ATTACHMENT A
EXISTING TECHNICAL SPECIFICATION
TABLE 3.3.1-1
SAN ONOFRE UNIT 2

ATTACHMENT C

SAN ONOFRE UNIT 2

**PROPOSED SAFETY ANALYSIS REPORT TEXT
SAN ONOFRE UNITS 2 & 3**

SAN ONOFRE NUCLEAR GENERATING STATION Units 2 & 3
CEA WITHDRAWAL AT LOW POWER CORE HEAT FLUX vs. TIME
Figure 15.4-7

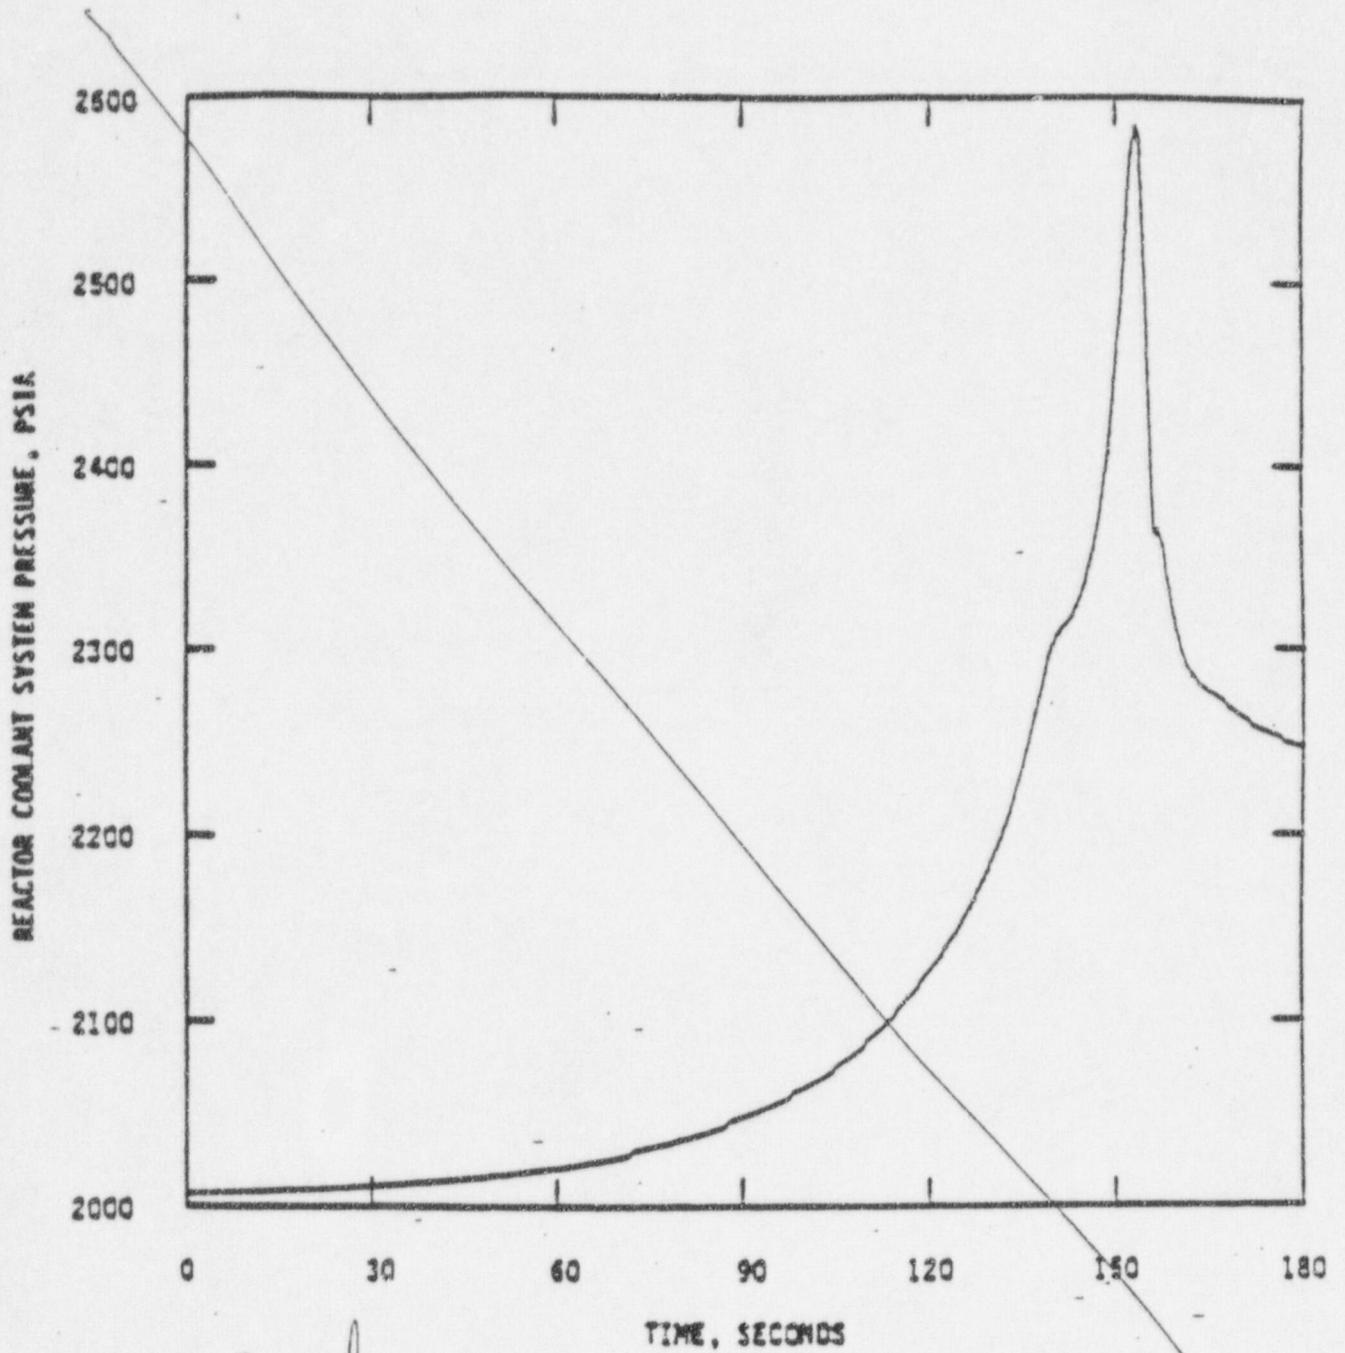
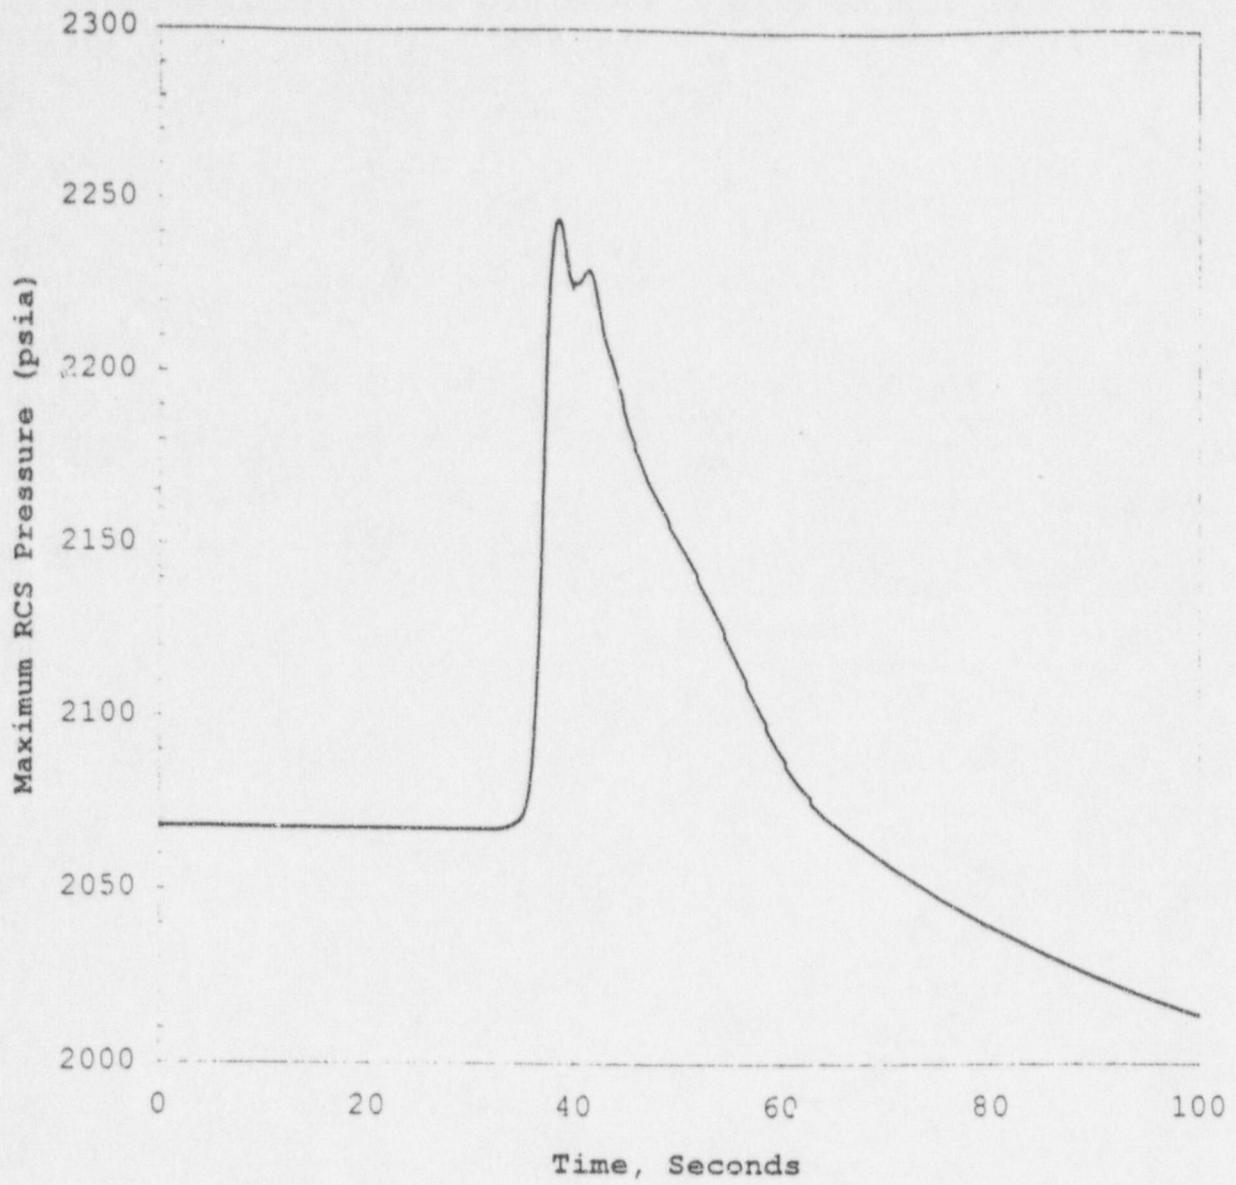
Replaces

Updated

SAN ONOFRE NUCLEAR GENERATING STATION UNITS 2 & 3
CEA WITHDRAWAL at LOW POWER HEAT FLUX FRACTION vs TIME
FIGURE 15.4-7

<p>SAN ONOFRE NUCLEAR GENERATING STATION Units 2 & 3</p>
<p>CEA WITHDRAWAL AT LOW POWER RCS PRESSURE vs. TIME</p>
<p>Figure 15.4-8</p>

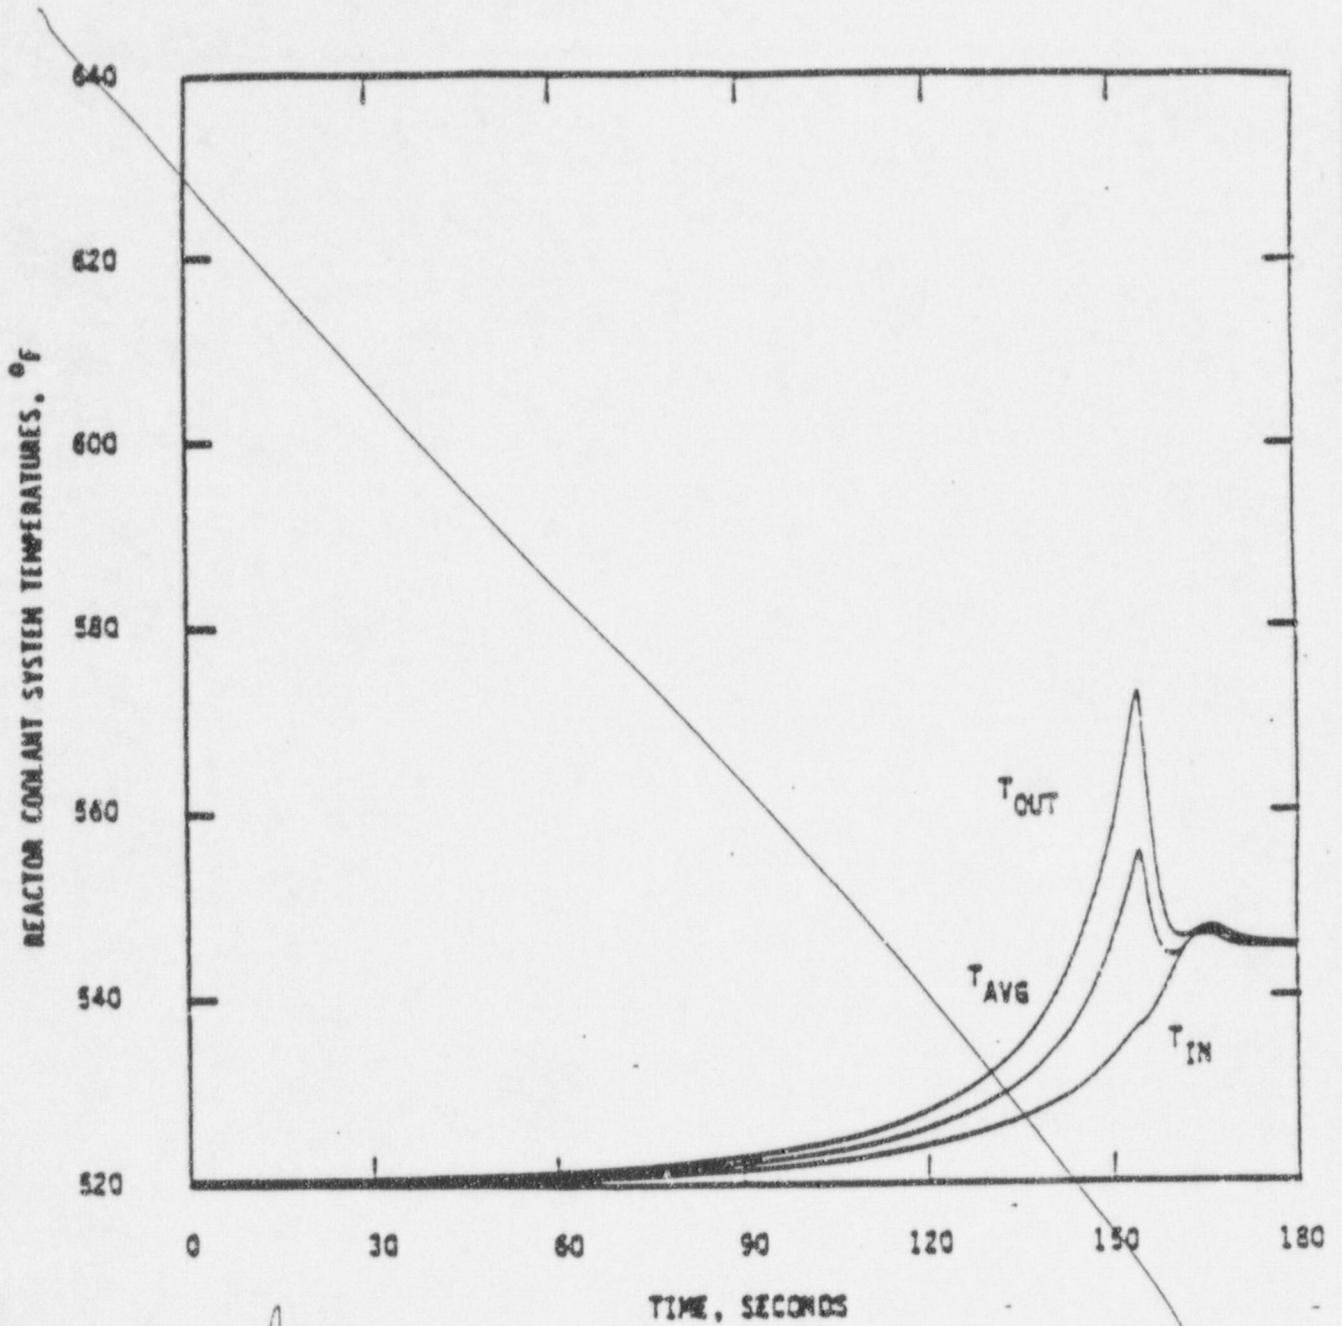
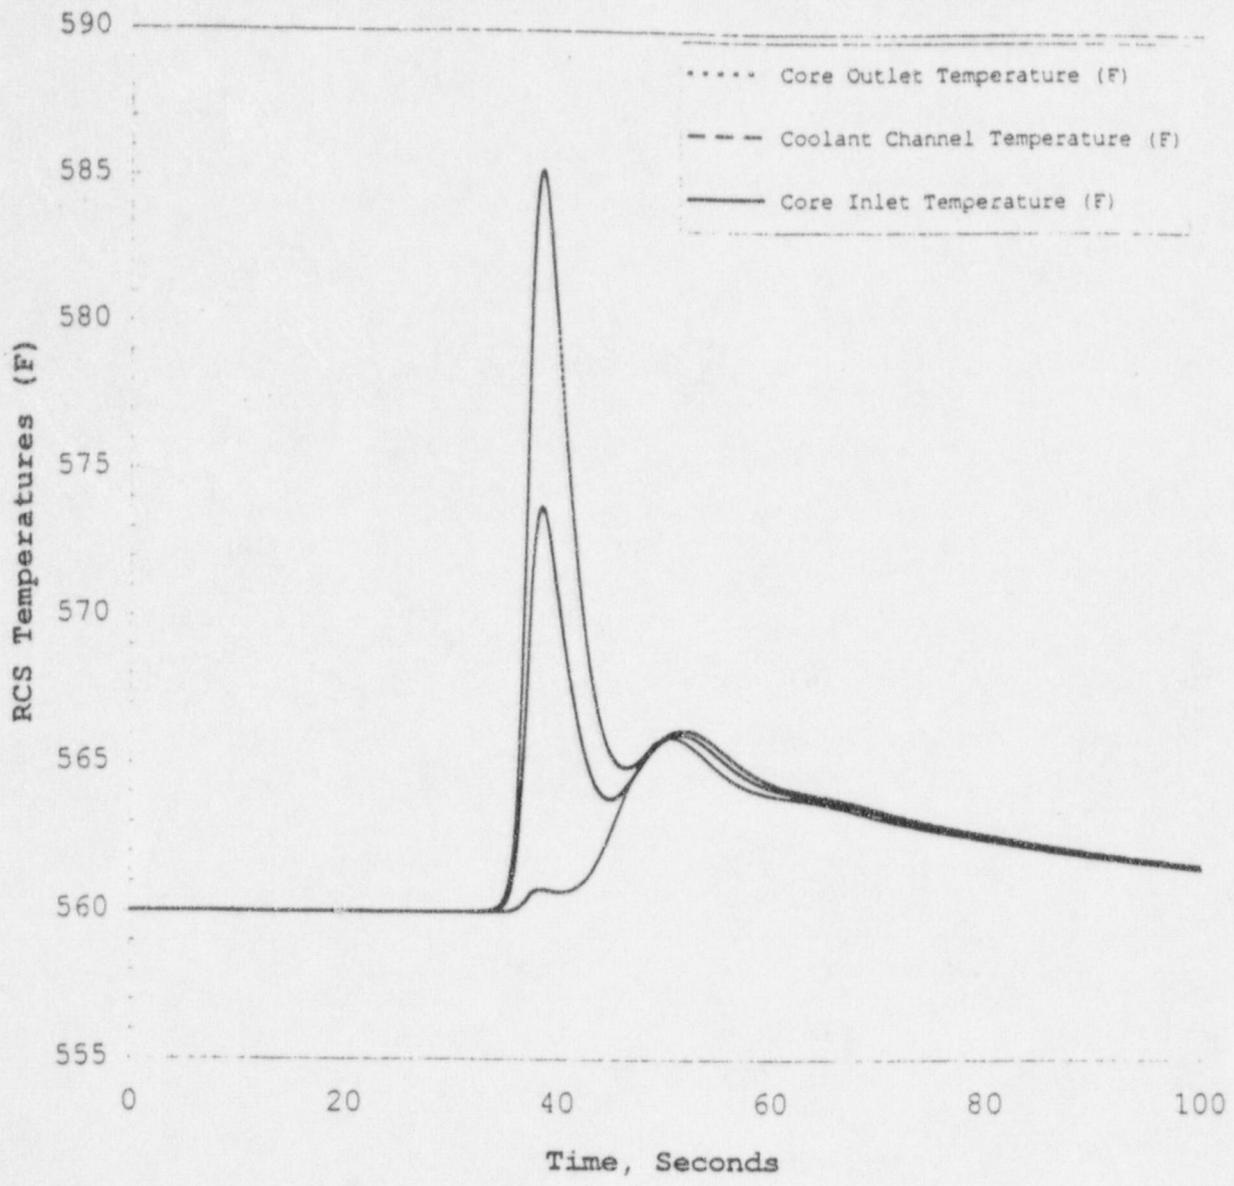
Kepler

Updated

SAN ONOFRE NUCLEAR GENERATING STATION UNITS 2 & 3
CEA WITHDRAWAL at LOW POWER RCS PRESSURE vs TIME
FIGURE 15.4-8

SAN ONOFRE NUCLEAR GENERATING STATION Units 2 & 3
CEA WITHDRAWAL AT LOW POWER RCS TEMPERATURES vs. TIME
Figure 15.4-9

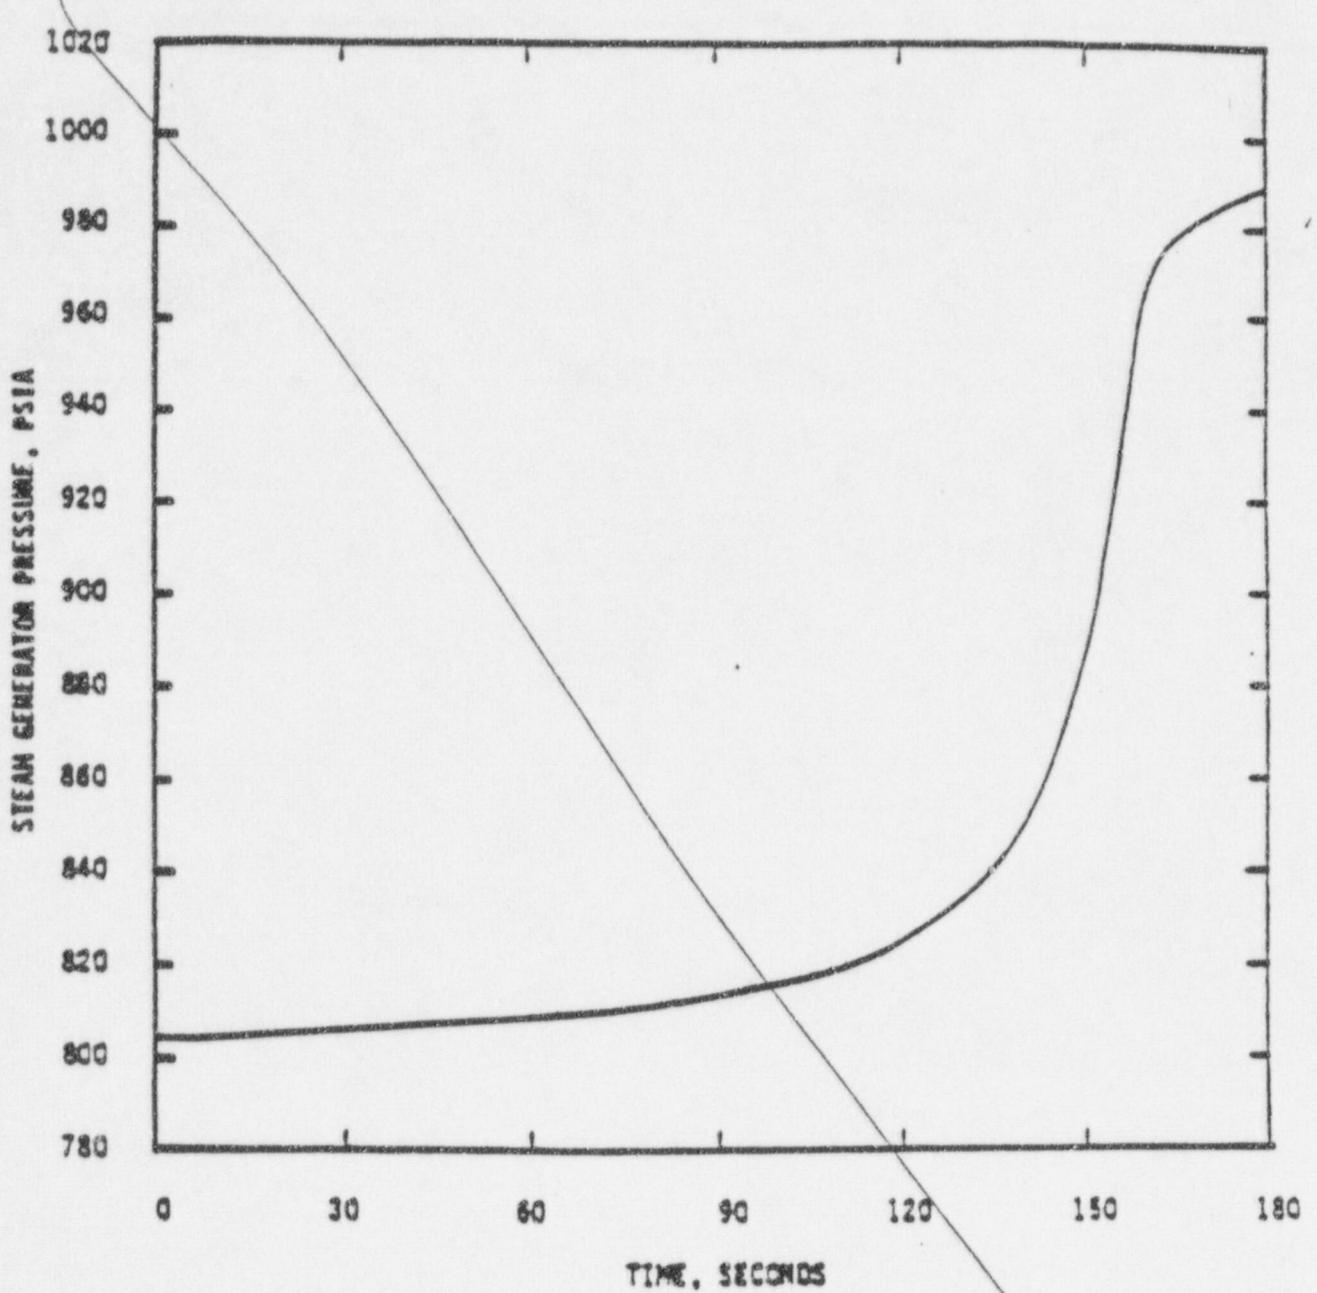
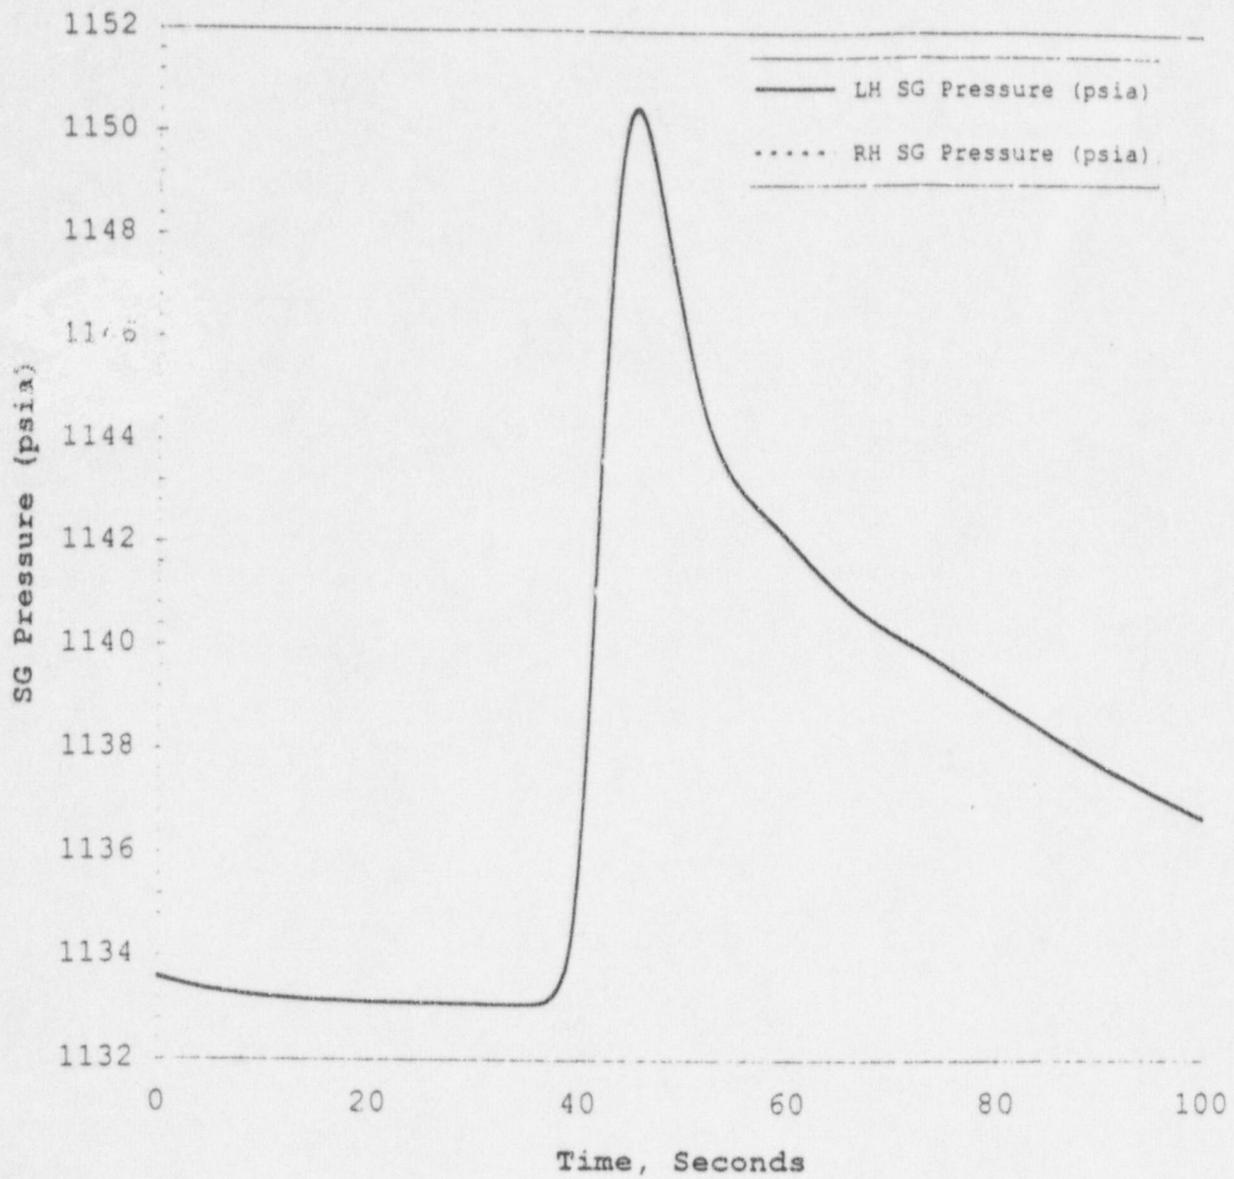
Kepler

Updated

SAN ONOFRE NUCLEAR GENERATING STATION UNITS 2 & 3
CFA WITHDRAWAL at LOW POWER RCS TEMPERATURES vs TIME
FIGURE 15.4-9

Updated
SAN ONOFRE
NUCLEAR GENERATING STATION
Units 2 & 3
CEA WITHDRAWAL AT LOW POWER
STEAM GENERATOR PRESSURE vs. TIME
Figure 15.4-10

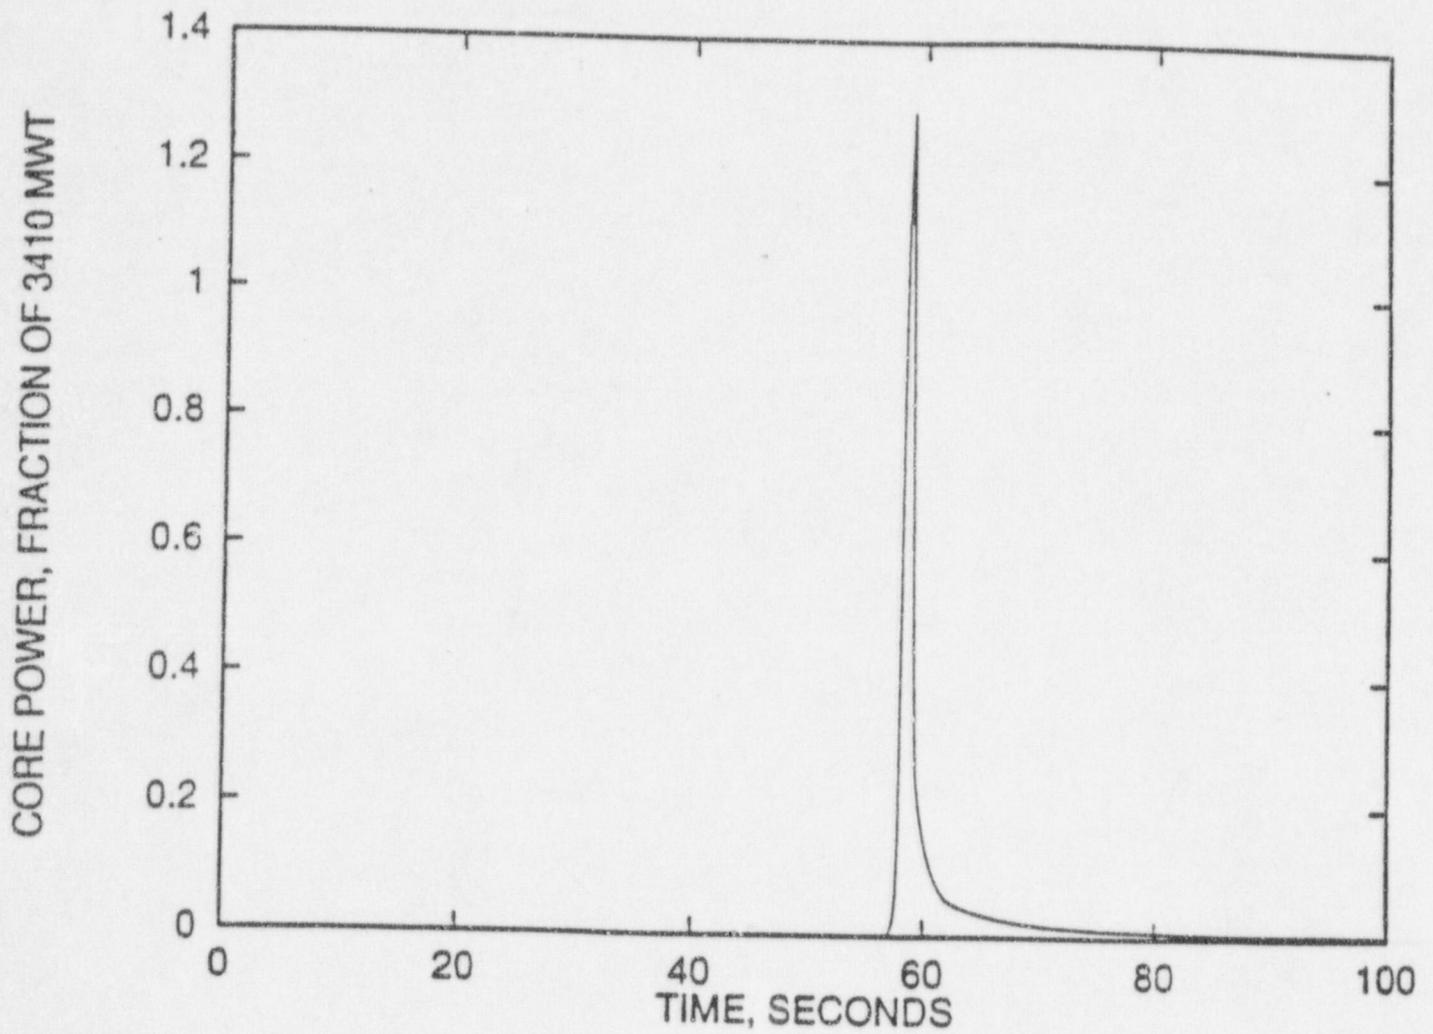
Repton

SAN ONOFRE NUCLEAR GENERATING STATION UNITS 2 & 3
CEA WITHDRAWAL at LOW POWER STEAM GENERATOR PRESSURE vs TIME
FIGURE 15.4-10
